HISTORIC DISTRICT COMMISSION ADDITIONAL INFORMATION REQUEST

Date: 7/10/25 Application Number: HDC2025-00305

PROJECT ADDRESS: 6108 28th Street

HISTORIC DISTRICT: St. Cyprian's Church

A201

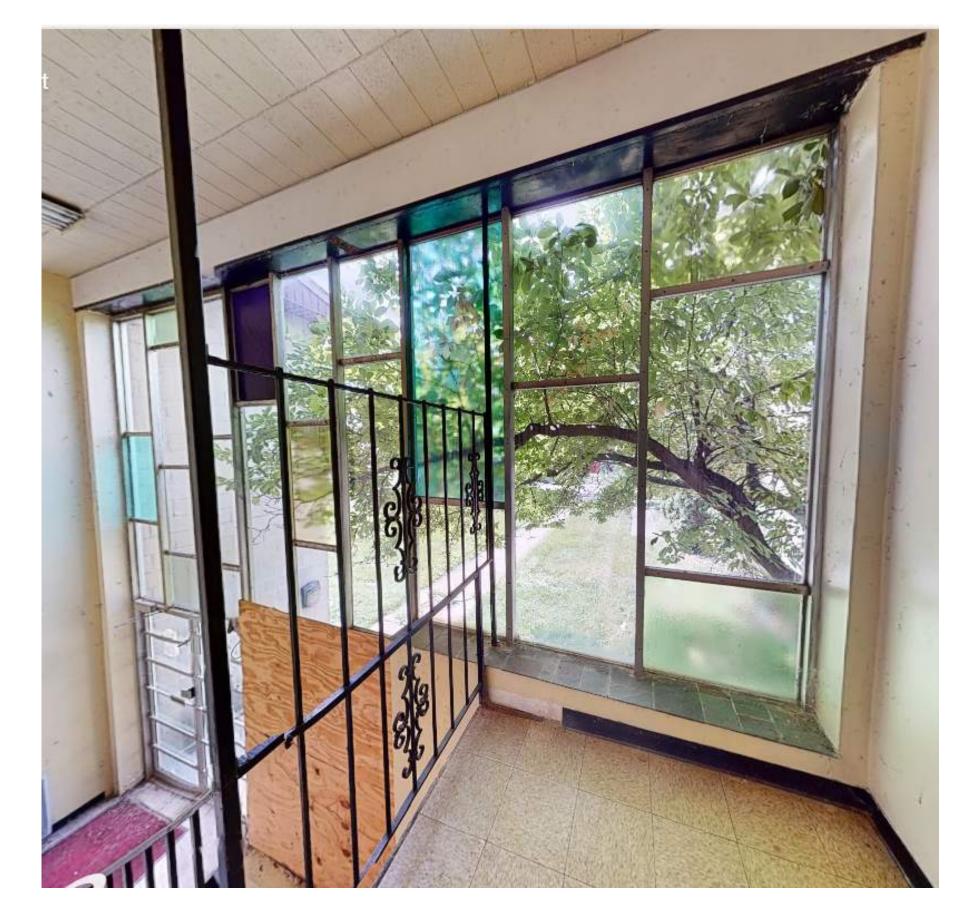
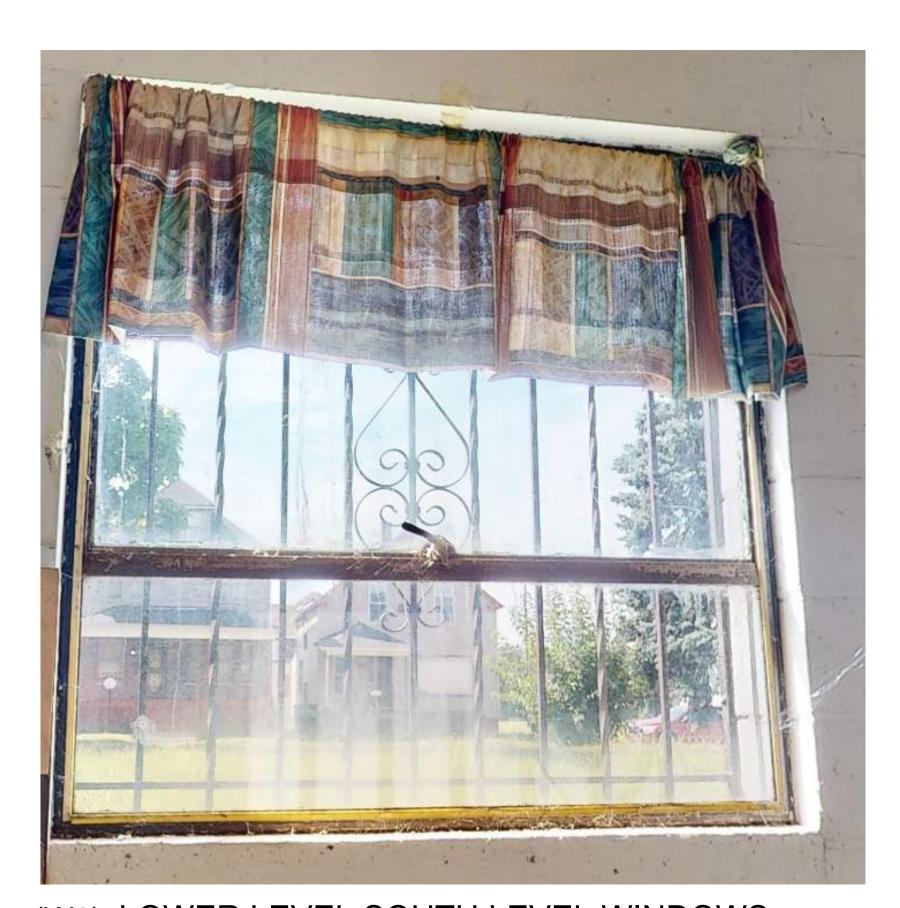
It appears that you plan to replace 34 windows, plus the storefront. Please confirm or correct.

- --Does Pella make grilles in all of the configurations needed to replicate the different window types? Can you provide the measurements for the components (rails, stiles, muntins/grilles) of the proposed windows?
- --Please share a window quote/estimate or draft order that shows the different windows you plan to order with the necessary grilles. It would be ideal if you could indicate which proposed windows on the order are which window types on your window schedule.

The number of windows to be replaced is 42 plus the storefront.

EXISTING WINDOWS **IMAGES**

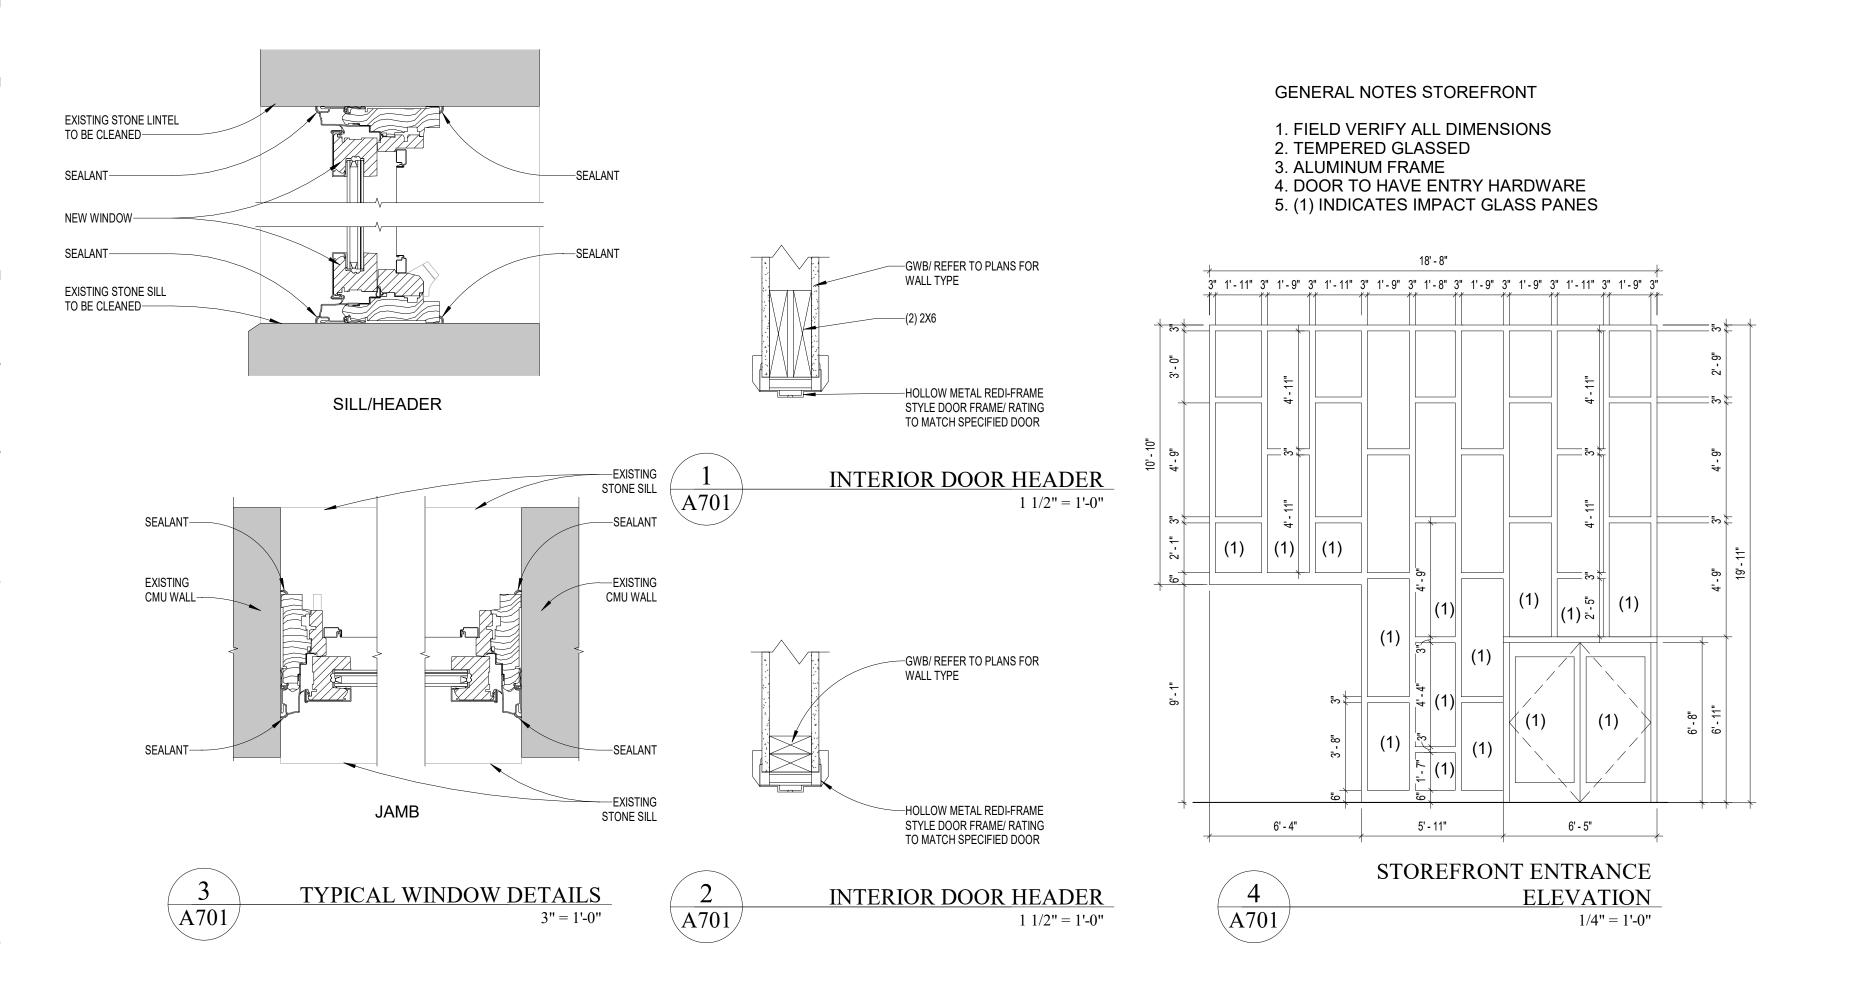
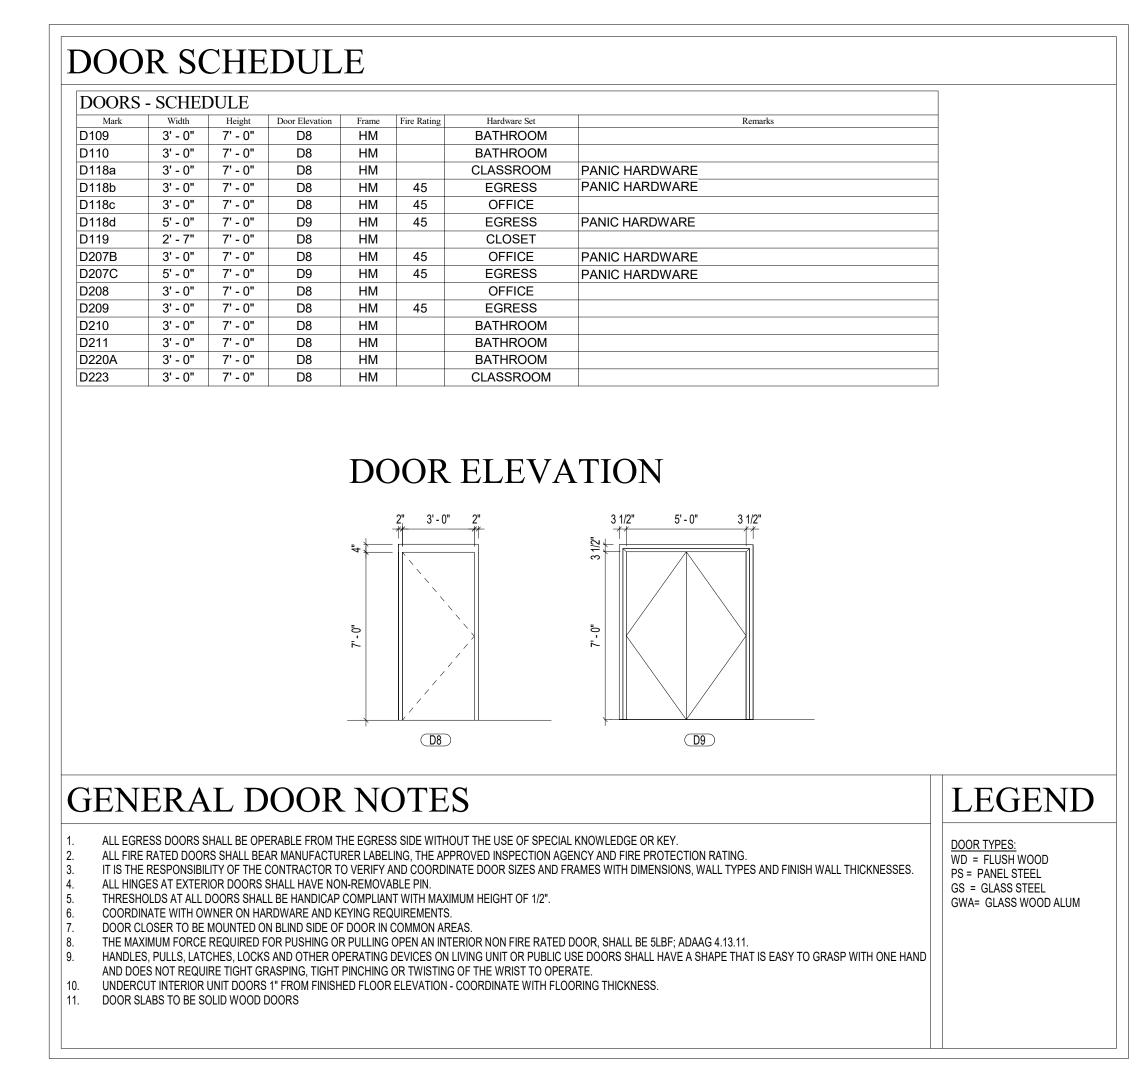
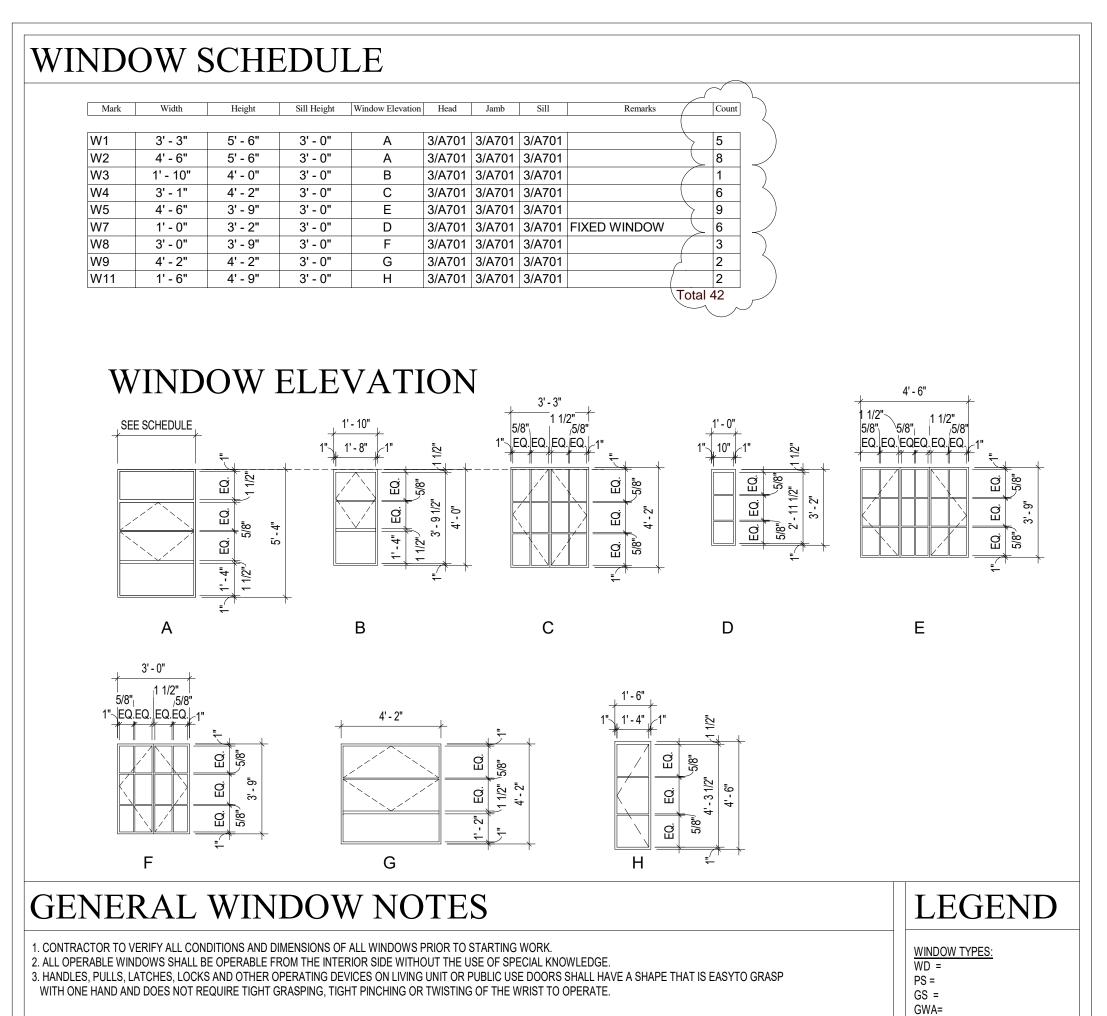
Before the commission can approve replacement windows, they need to understand the conditions of the existing windows. Please provide photos showing the conditions of each window proposed for replacement, including photos of both interior and exterior.

Attached is as many images as I could get of the windows and storefront. Client is currently out of the country.
